Access Compliance Report Public Rights-of-Way (Curb Ramps)

Main Street: **MARIAN_AVE** Cross Street: **THISTLE_RD** Location: **NE**

ADA ID: **RPAT211130132010** Ramp Type: **Type 6 - Directional 1** Initial Pass/Fail: **Fail** Overall Compliance: **No** Severity Score: **0**

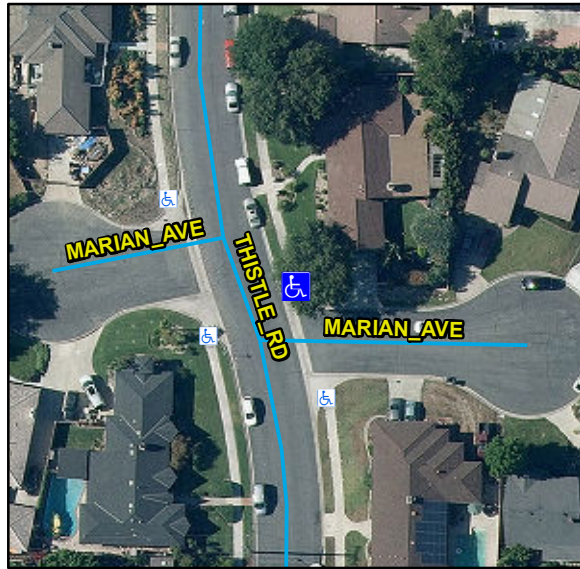
Surveyor Notes:

Possible Solutions:

Remove & Replace Entire Ramp.
